BLUE BIRD

**SUBJECT: SERVICE BULLETIN S07LU C.E. WHITE CHILD RESTRAINT
TRACK MOUNTED SEATS WALL ATTACHING BRACKET**

**AFFECTED: CERTAIN 2006 MODEL YEAR ALL AMERICAN FRONT ENGINE
BUSES**

Seat Mounting Bracket

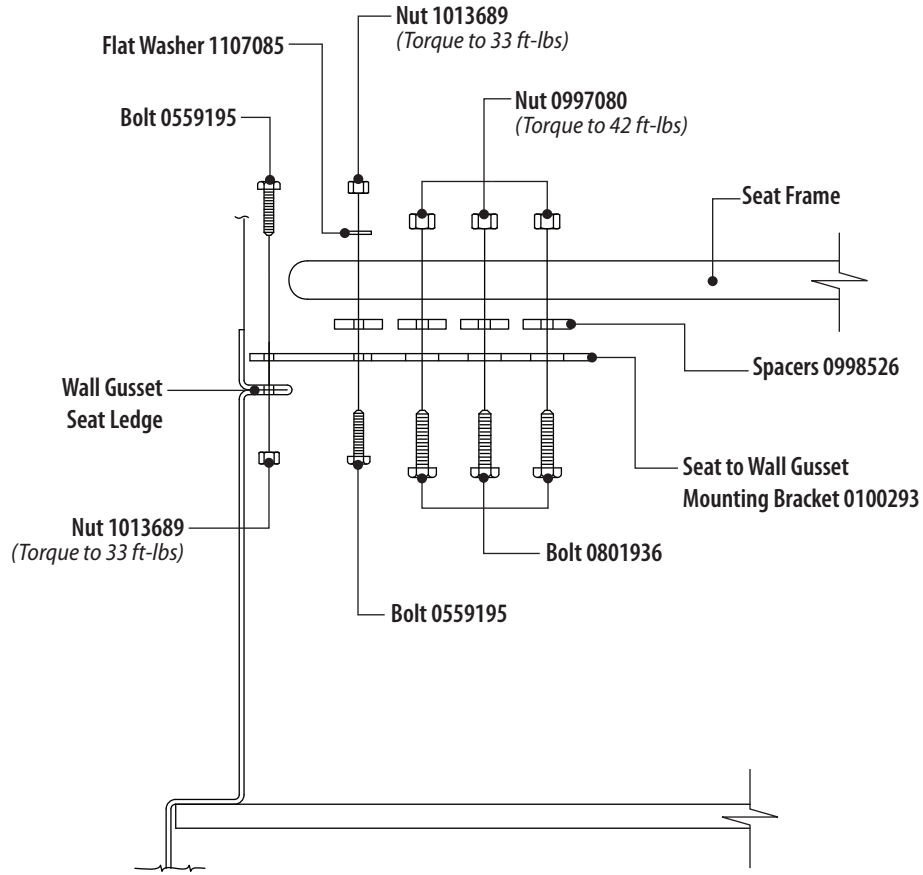
The seat to wall gusset mounting bracket on CE White Child Restraint track mounted seats located above the front wheelhousing may crack and break.

Determine which track mounted seats over the front wheelhousing are installed with a seat to wall gusset mounting bracket and replace the mounting bracket.

- 1** Park vehicle on a level surface, apply parking brake, turn engine off and remove ignition key.
- 2** Remove seat cushion.
- 3** Remove and discard seat to wall gusset mounting bracket and all attaching hardware.
- 4** Attach the new bracket 0100293 to seat frame with fasteners and spacers, per diagram on page 2.

- 5** Place the seat and bracket on top of wall gusset seat ledge. Using the new bracket as a guide, drill three (3) 13/32" diameter holes. Attach bracket to gusset seat ledge per diagram, page 2.
